Model: PRIORT EMERALD/TOPAZ		Date: 1-Dec-05	No: R-C262-001
Subject: Firmware Release History (ACU)		Prepared by: K. Yamamoto, Priort Service Planning Section	
Classification:	<input type="checkbox"/> Troubleshooting <input type="checkbox"/> Part information <input type="checkbox"/> Action required <input type="checkbox"/> Mechanical <input type="checkbox"/> Electrical <input type="checkbox"/> Service manual revision <input type="checkbox"/> Paper path <input type="checkbox"/> Transmit/receive <input type="checkbox"/> Retrofit information <input checked="" type="checkbox"/> Other ()		
Model Name: EMERALD: Ricoh HQ9000, Gestetner CP6346, RexRotary CP6346, nashuatec CP6346, Savin 3590DNP, Standard SD700, Lanier LDD280 TOPAZ: Ricoh HQ7000, Gestetner CP6334, RexRotary CP6334, nashuatec CP6334, Savin 3580DNP, Standard SD460, Lanier LDD250

Model: PRIPORT EMERALD/TOPAZ		Date: 1-Dec-05	No: R-C262-002a
Subject: Firmware Release History (Language)		Prepared by: K. Yamamoto, Priport Service Planning Section	
Classification: <input type="checkbox"/> Troubleshooting <input type="checkbox"/> Part information <input type="checkbox"/> Action required <input type="checkbox"/> Mechanical <input type

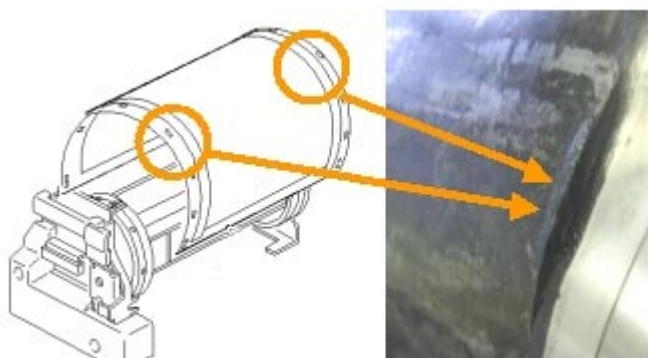
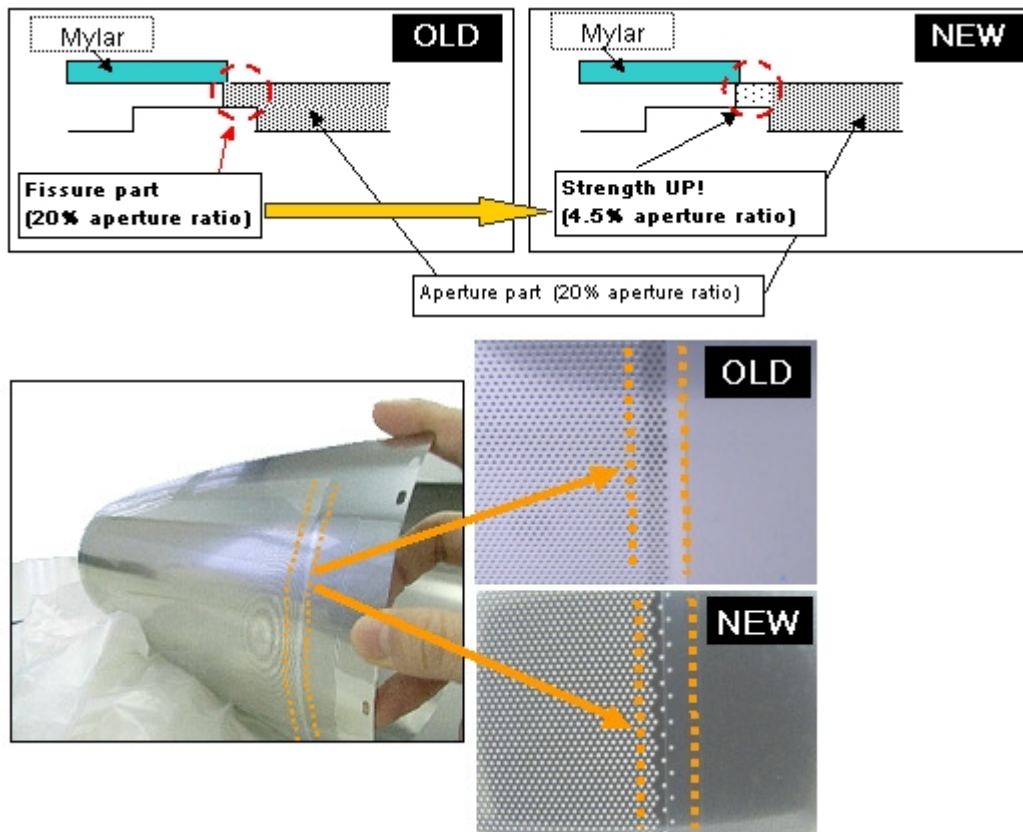
The edge of the metal screen breaks

SOLUTION

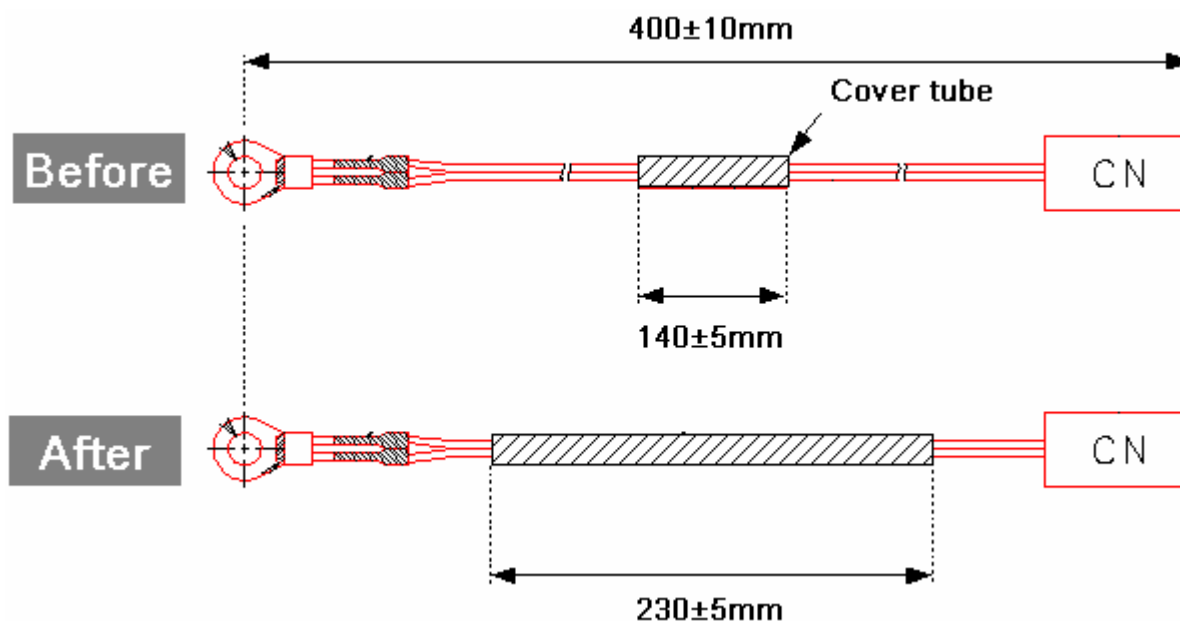
The cover tube of the thermistor breaks, sometimes triggering SC307 ("Hot ink").

OLD and NEW brackets:

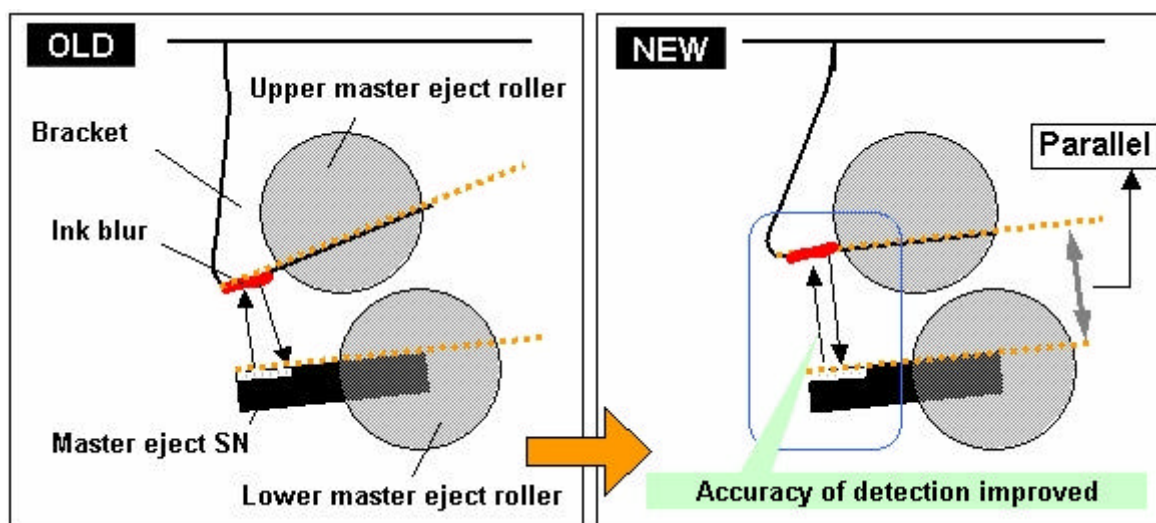
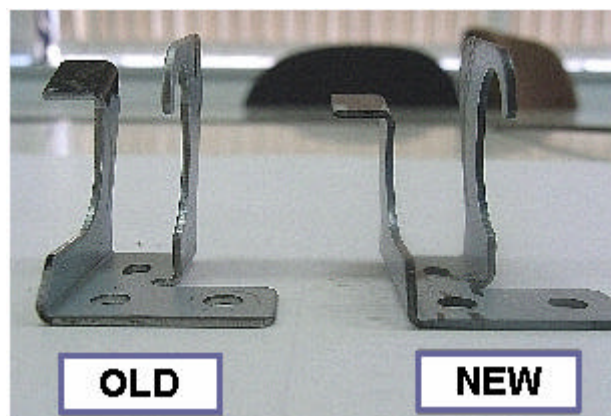
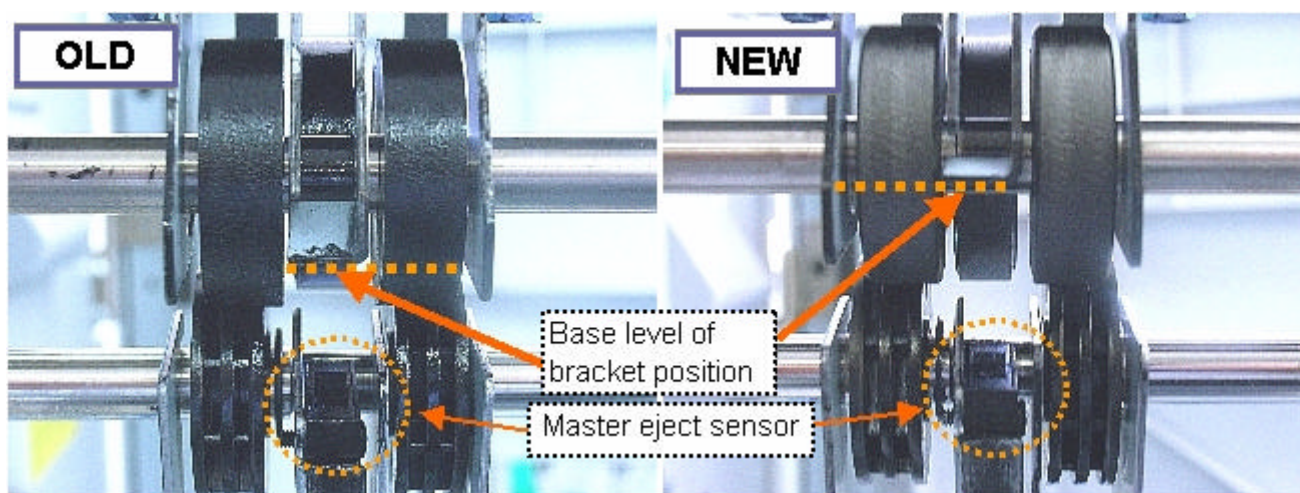
Ink sticks to the bracket for the master eject sensor.

Replace the bracket for the master exit sensor.

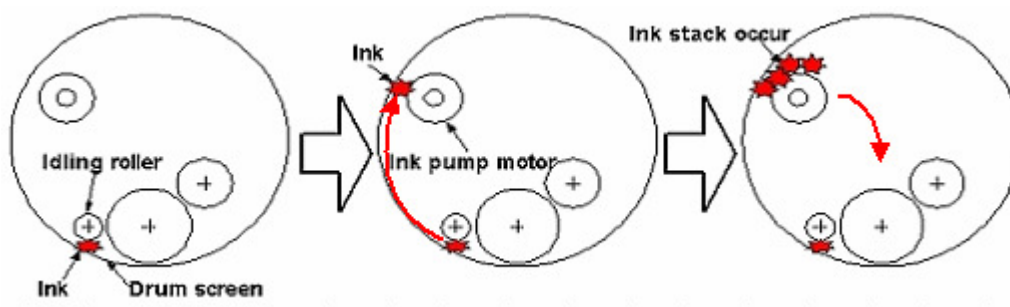
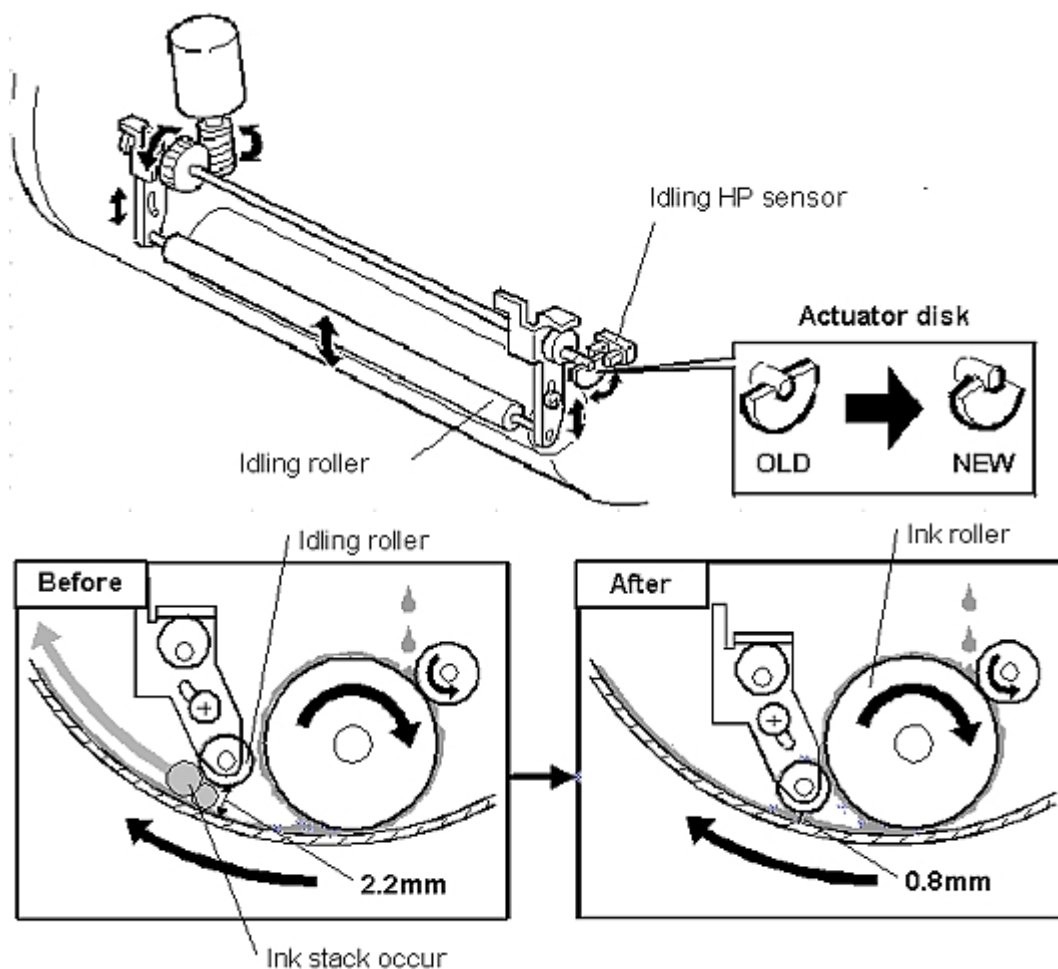
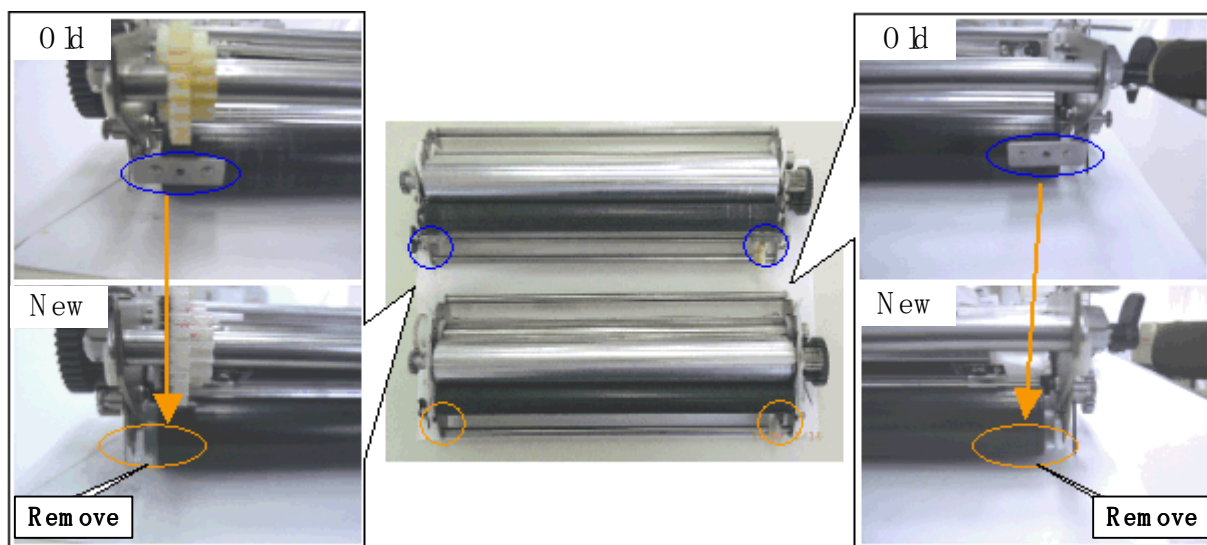
Lumps of ink build up on the ink pump motor, and eventually the ink begins dropping into the drum and sticks to the drum surface.

1. The shape of the actuator for the idling HP sensor was changed.

Note: As a result, the gap between the idling roller and metal screen is now narrower than before (2.2mm to 0.8mm). The idling roller will be rotated with the metal screen, which will prevent the ink from building up.

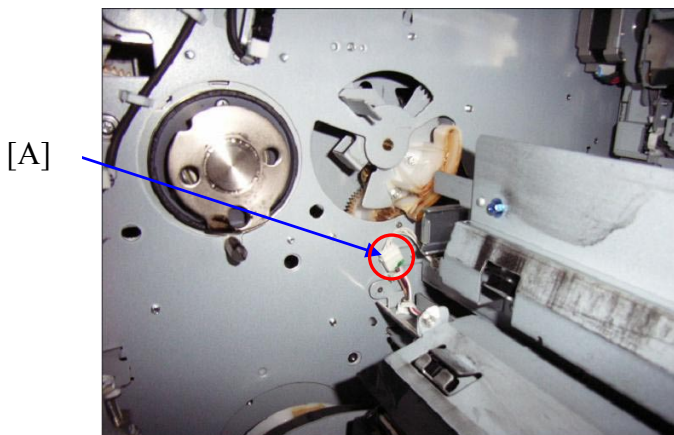
Important: The feeding performance for thin paper may decrease with this change.

- On machines produced **from** the cut-in serial number:
When printing envelopes, set "Special Paper" as the paper type in User Mode.

- On machines produced **before** the cut-in serial number:
 - Remove the Mylars and replace the paper feed guide plate.

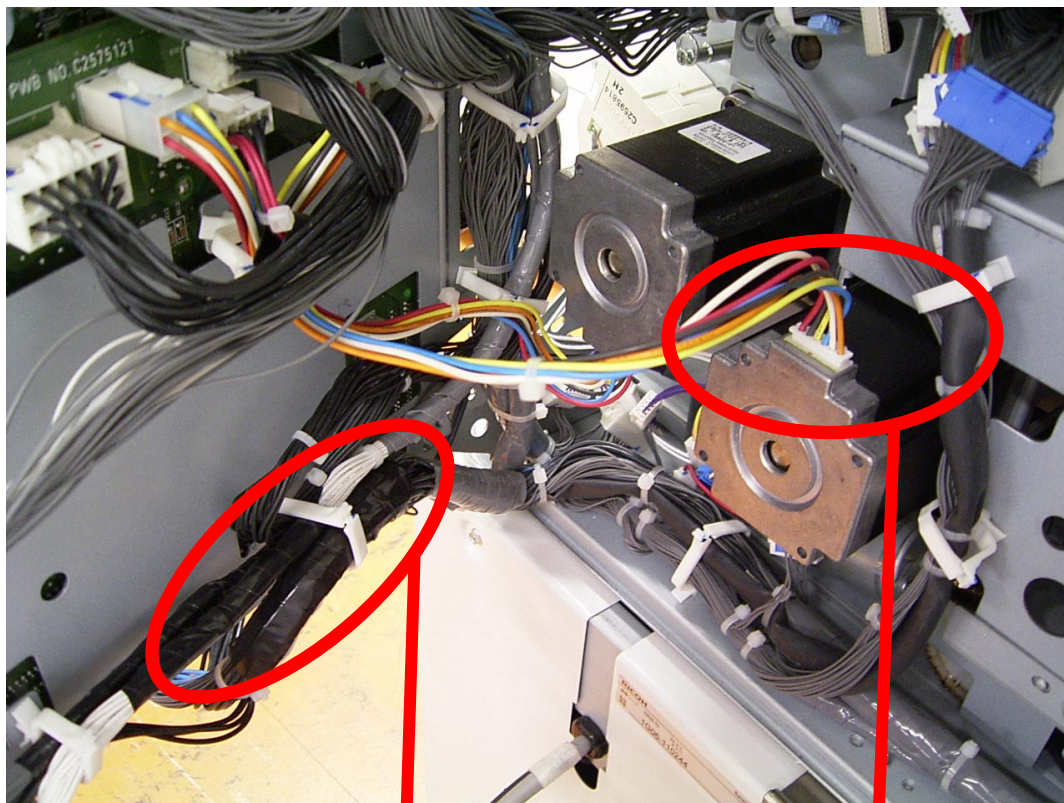
The covers of the harnesses around the registration motor are damaged, which triggers a short circuit.

- The registration motor is now attached in a different direction so that the harness connector is at the top (180 degrees from its current position).
- Tape was added to the harness to further protect the harness.

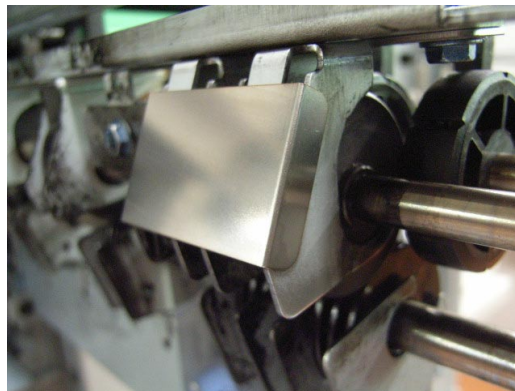
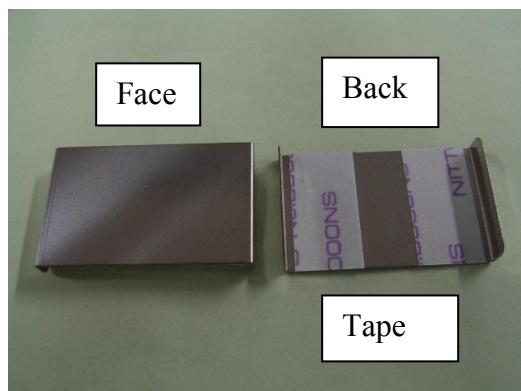
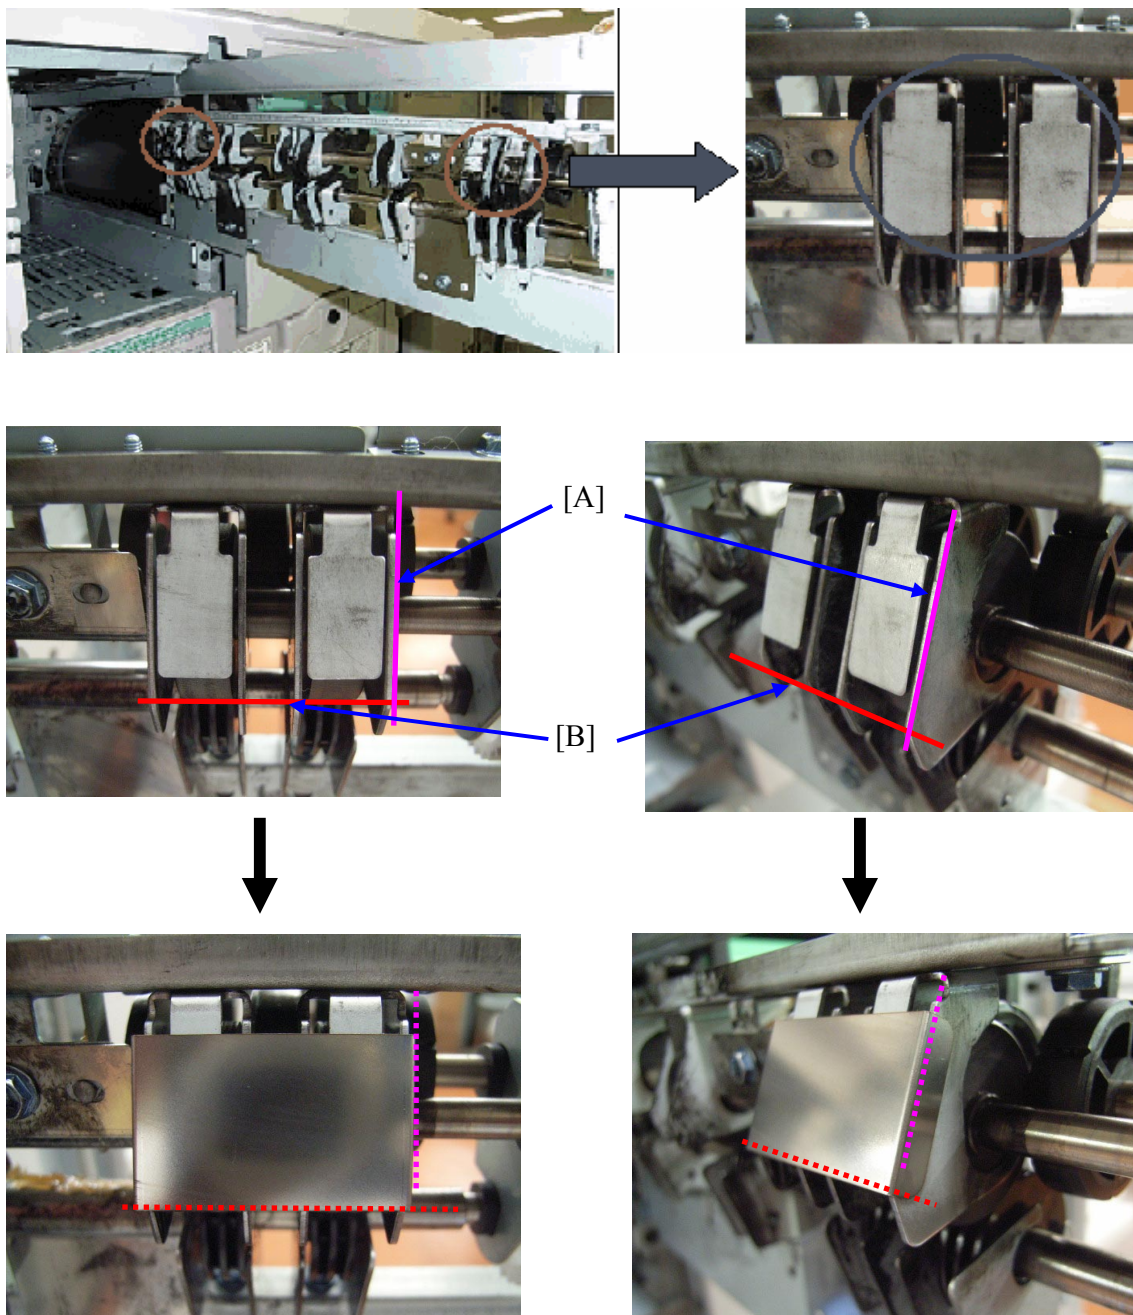
Covers have been added for the master eject rollers.

Attach the new covers (P/N C2653620).

Attach the two covers to the two surfaces circled in the photos below.

Important: Align the edges of the covers with lines [A] and [B].

Old: B2135222

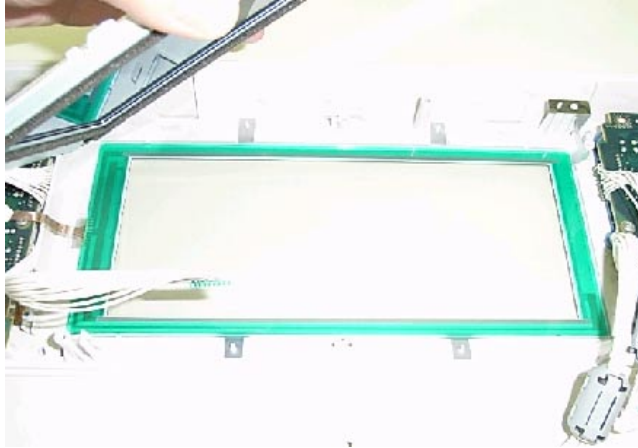
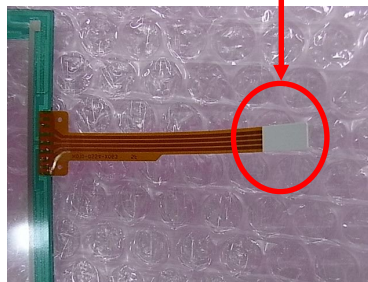
Note: The end of the new touch panel harness is **white**.

6. Remove the touch panel from the LCD and replace the touch panel.

Important: Only replace the touch panel. Do not replace the LCD.

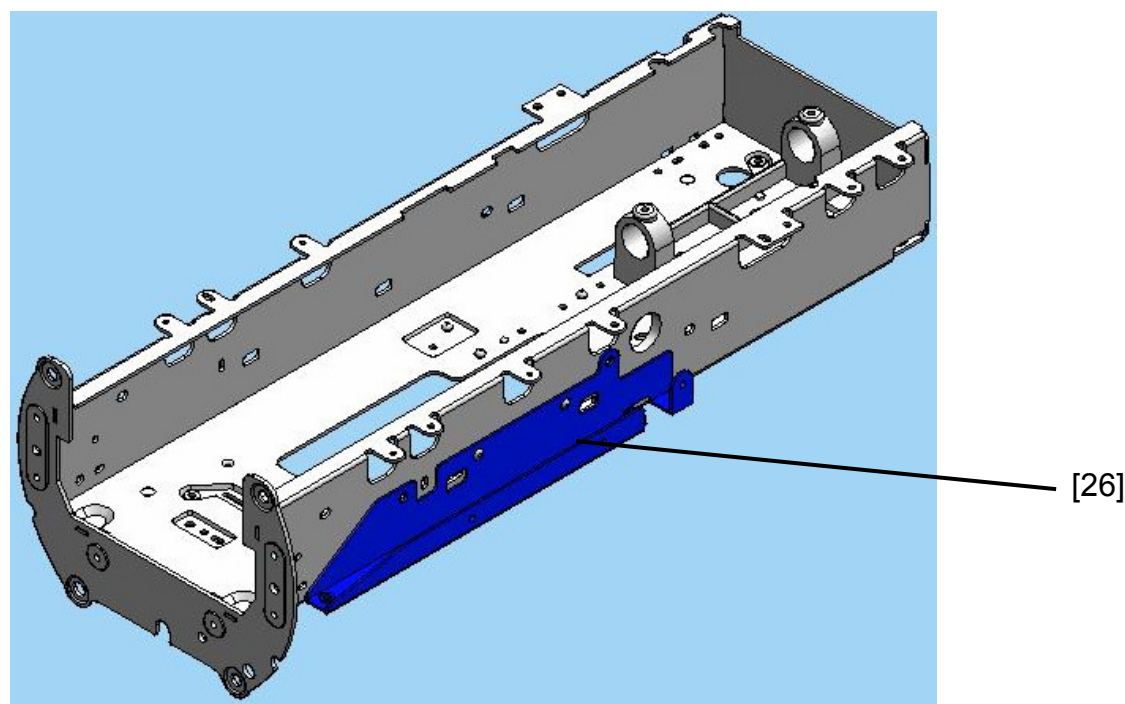
- 1) The material of the drum frame was changed.
- 2) As a result, the shapes of the frame and pins were changed and
- 3) A harness bracket was added.

Reason: To further increase the reliability of the drum frame.

The shape of hole is changed

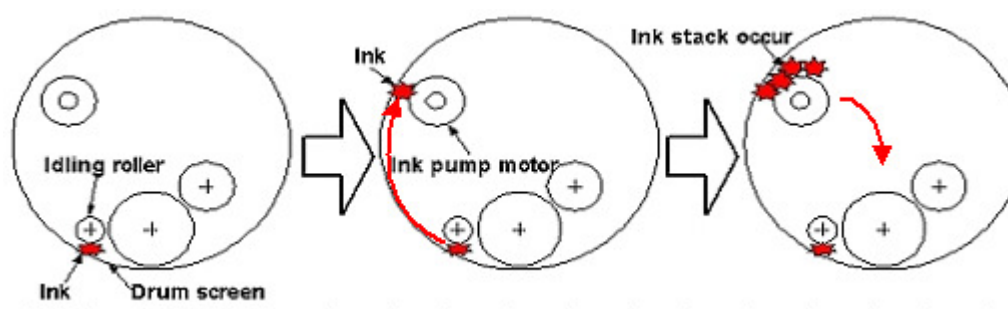
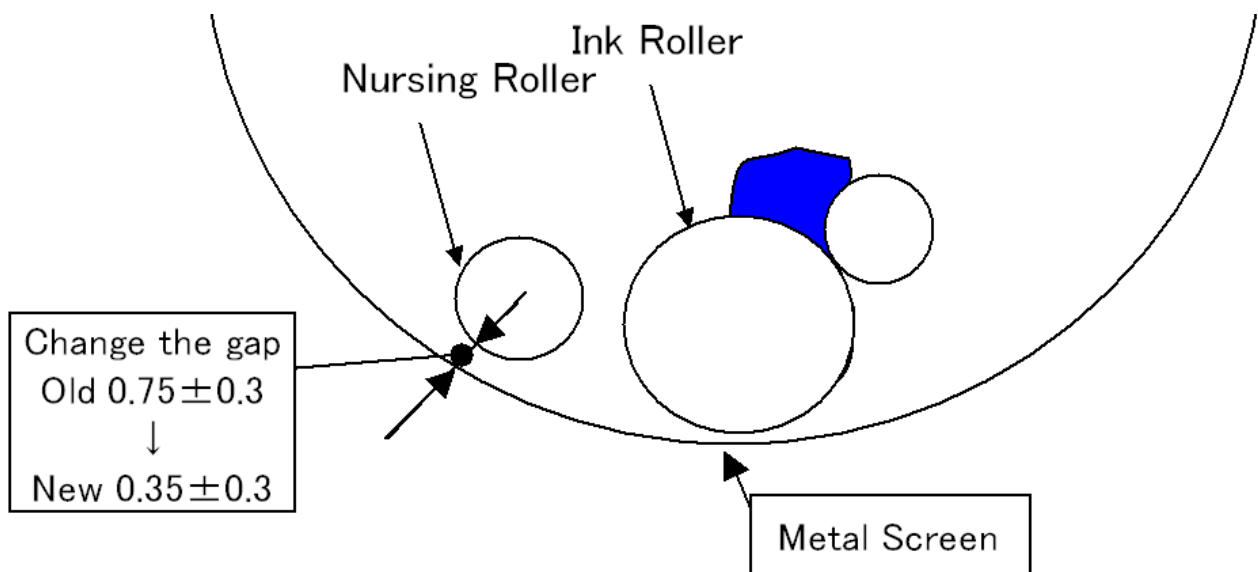
Lumps of ink build up on the ink pump motor and eventually drop onto the drum and stick to the drum surface.

Reason: To ensure that the ink is applied more smoothly and does not build up on the roller.
